Access Compliance Report

Public Rights-of-Way

Intersection ID: 42489	Main Street: ALEXANDER MARTIN AV	Cross Street: LINA ARDREY LN	Location: NE
ADA ID: 5FDACAFCD0B3	Ramp Type: Combination1Diag	Initial Pass/Fail: Fail	Overall Compliance: No
		Severity Score: 0

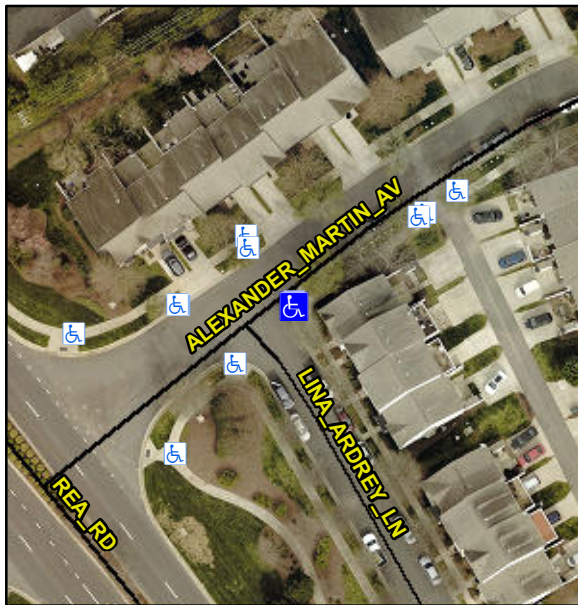
RP & RT RP < 5%

R304.5.1, R304.5.3

Remove & Replace Curb Ramp With Two New Directional Ramps or Equivalent.
